Docket Number:	79-AFC-03C
Project Title:	Compliance - Application for Certification of PG&E Geysers Unit 18
TN #:	222334
Document Title:	Geysers Power Company, LLC - Consolidated Petition for a Staff Approved Modifications
Description:	FOR GEYSERS UNIT 16 (79-AFC-5C), UNIT 18 (79-AFC-3C), and UNIT 20 (82-AFC-1C)
Filer:	Raquel Rodriguez
Organization:	Geysers Power Plant
Submitter Role:	Applicant
Submission Date:	1/23/2018 10:16:10 AM
Docketed Date:	1/23/2018

GEYSERS POWER COMPANY, LLC
CONSOLIDATED PETITION FOR A STAFF APPROVED MODIFICATIONS

GPC Quicksilver Power Plant
GPC Socrates Power Plant
GPC Grant Power Plant
Geysers Unit 16 Docket: 79-AFC-OSC
Geysers Unit 18 Docket: 79-AFC-OJC
Geysers Unit 20 Docket: 82-AFC-01C

CALPINE CORPORATION		JOB NUMBER	144890
COOLING TOWER		REV	△
FIELDWIDE UPGRADES		DRAWING NUMBER	16M1-1
UNIT 16 SITE PLAN			
FIRE PREVENTION UPGRADES

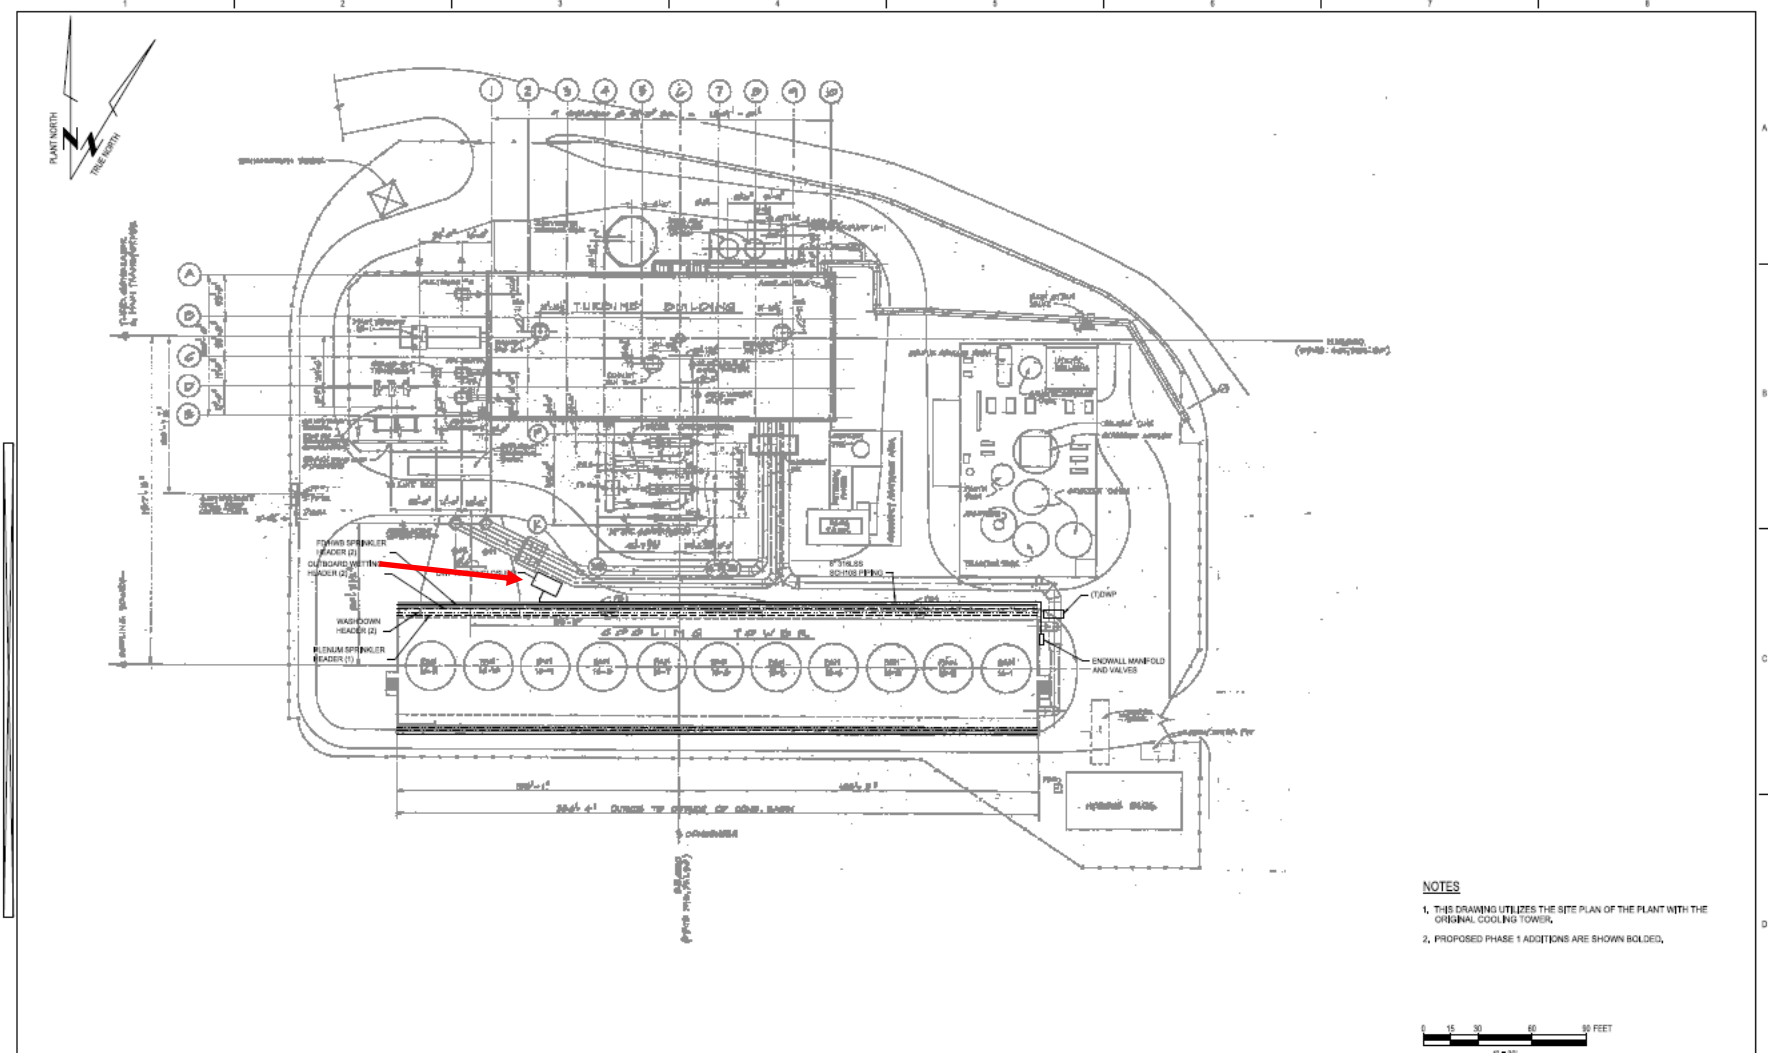
- NOTES**
1. THIS DRAWING UTILIZES THE SITE PLAN OF THE PLANT WITH THE ORIGINAL COOLING TOWER.
 2. PROPOSED PHASE 1 ADDITIONS ARE SHOWN BOLD.

New DWP

CALPINE CORPORATION	JOB NUMBER	REV
		COOLING TOWER FIELDSIDE UPGRADES	144892	△
UNIT 18 SITE PLAN FIRE PREVENTION UPGRADES		DRAWING NUMBER		
		18M1-1

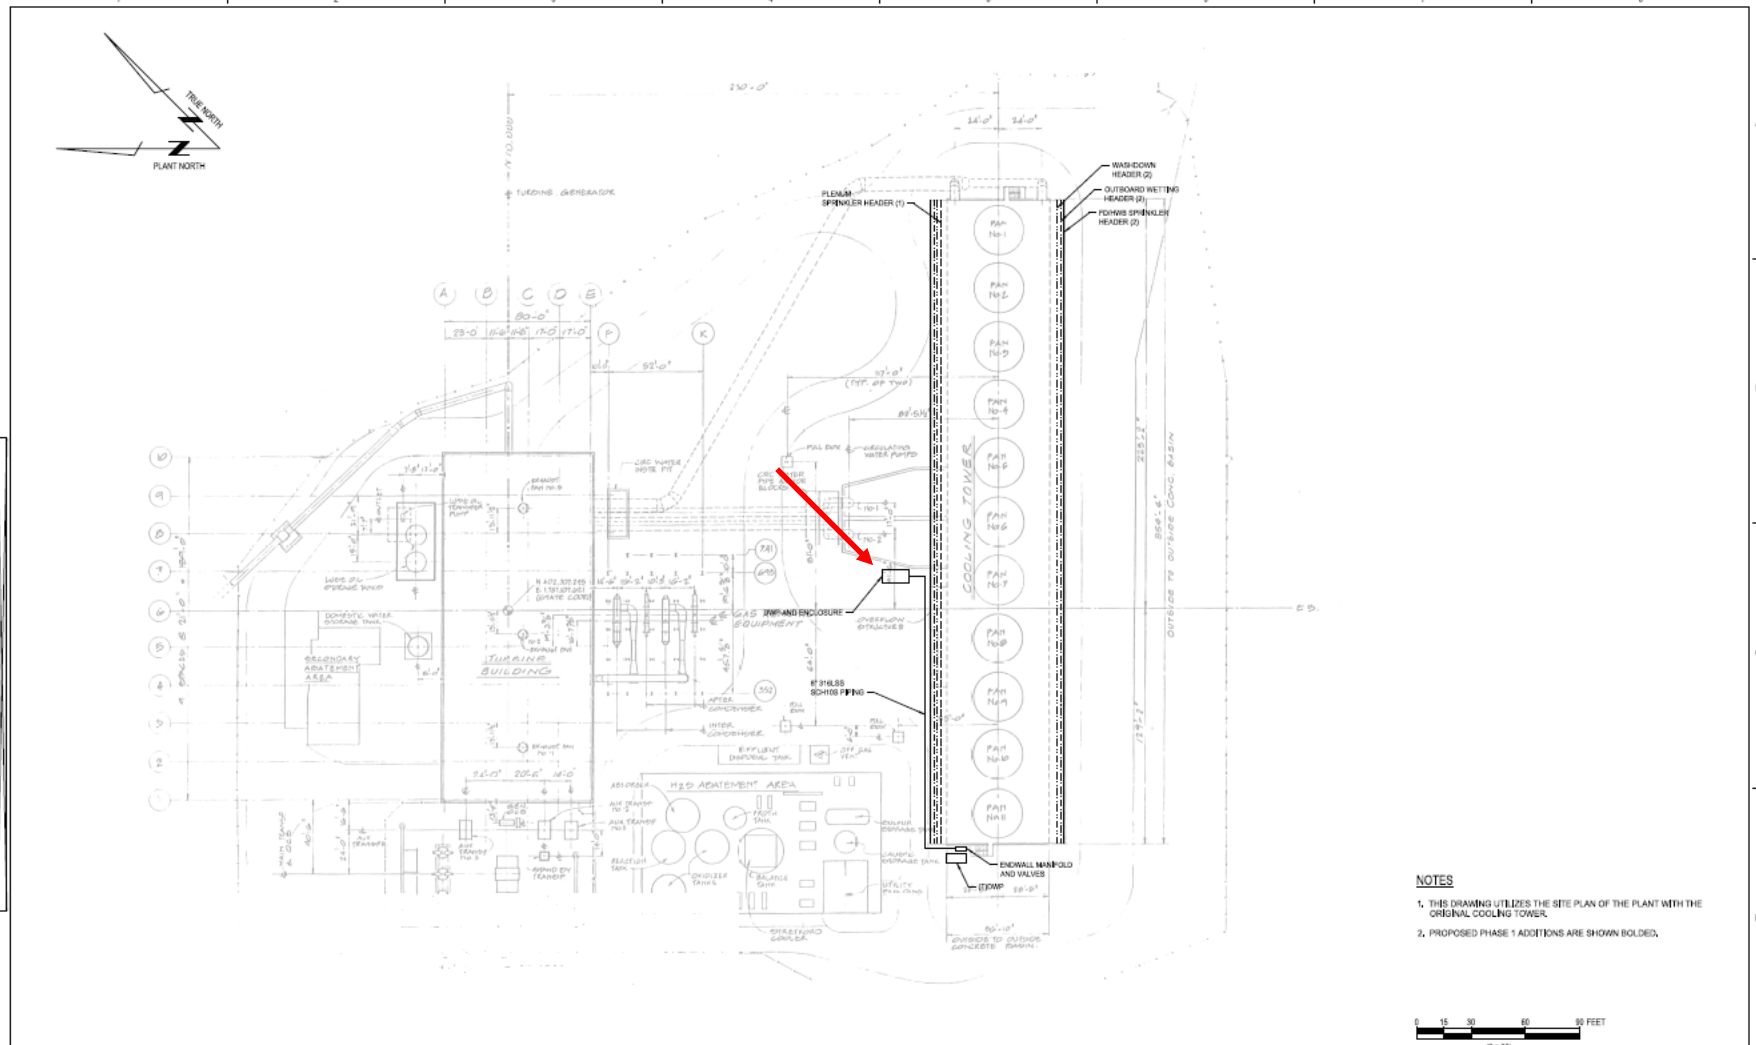
1. THIS DRAWING UTILIZES THE SITE PLAN OF THE PLANT WITH THE ORIGINAL COOLING TOWER.
2. PROPOSED PHASE 1 ADDITIONS ARE SHOWN BOLD.

New DWP

CALPINE CORPORATION	JOB NUMBER	REV
COOLING TOWER FIELDWIDE UPGRADES	144890	△
UNIT 20 SITE PLAN FIRE PREVENTION UPGRADES	DRAWING NUMBER	
	20M1-1

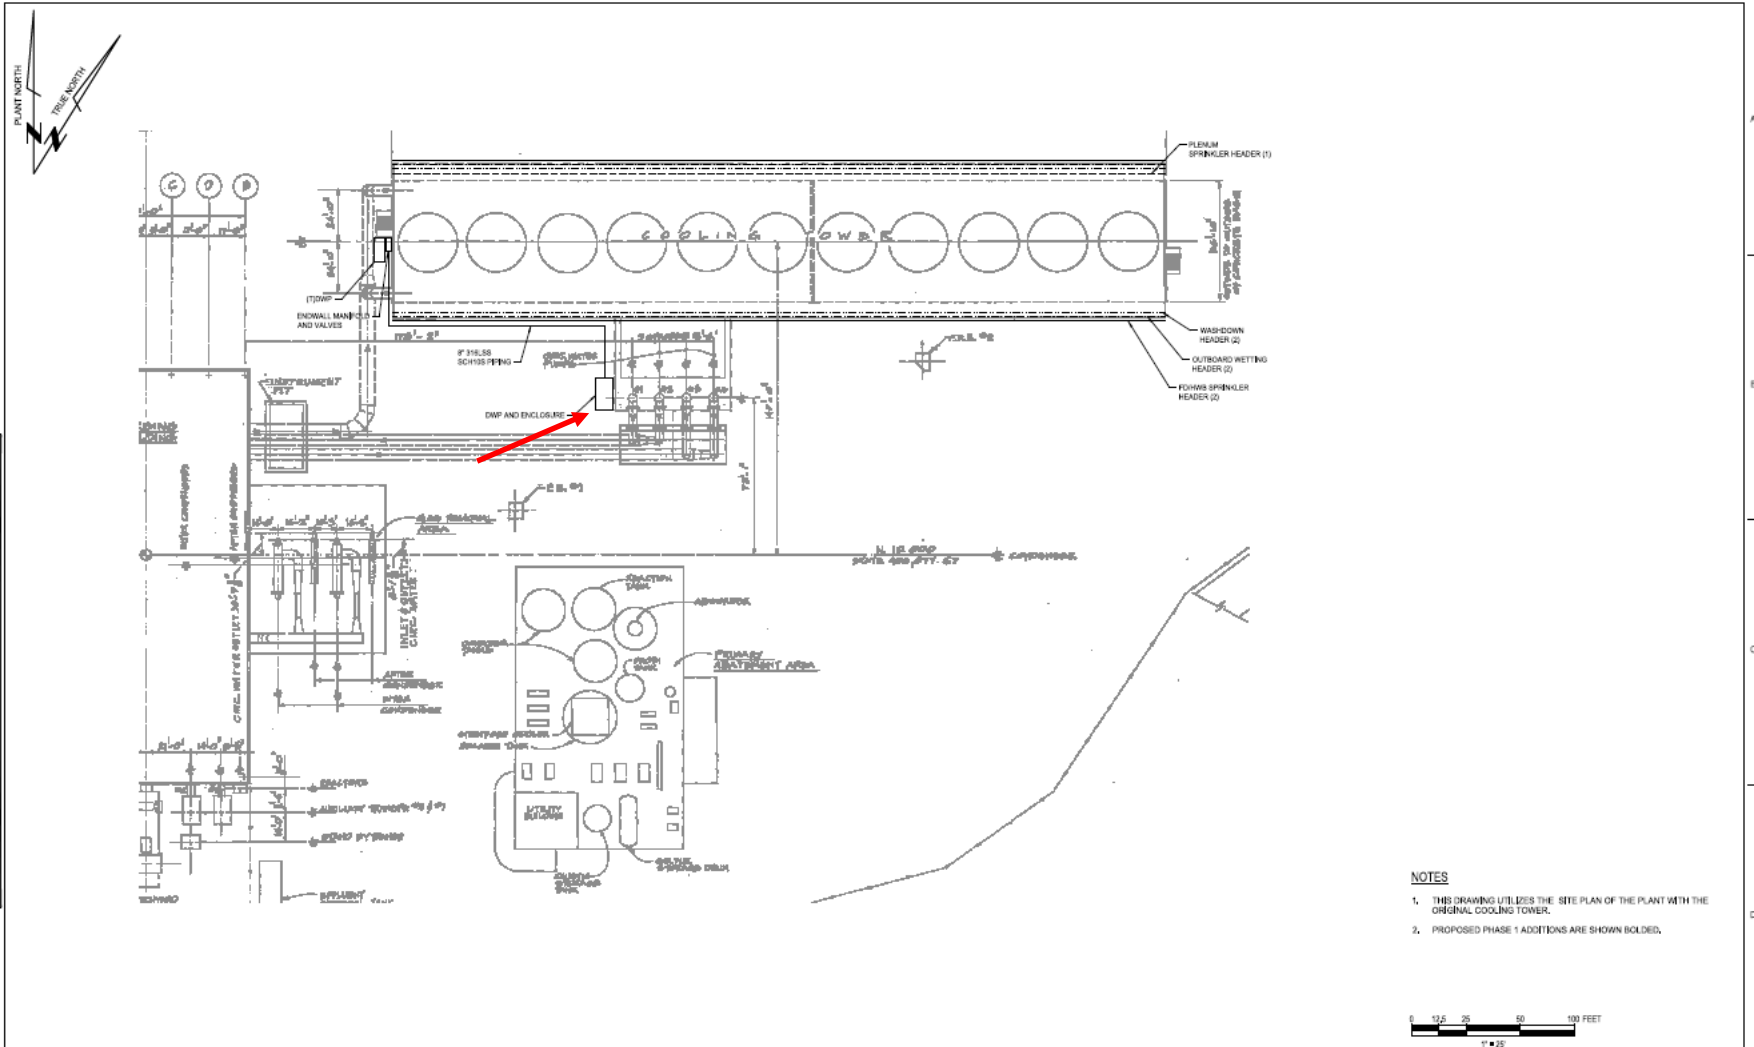
- NOTES**
1. THIS DRAWING UTILIZES THE SITE PLAN OF THE PLANT WITH THE ORIGINAL COOLING TOWER.
 2. PROPOSED PHASE 1 ADDITIONS ARE SHOWN BOLDED.
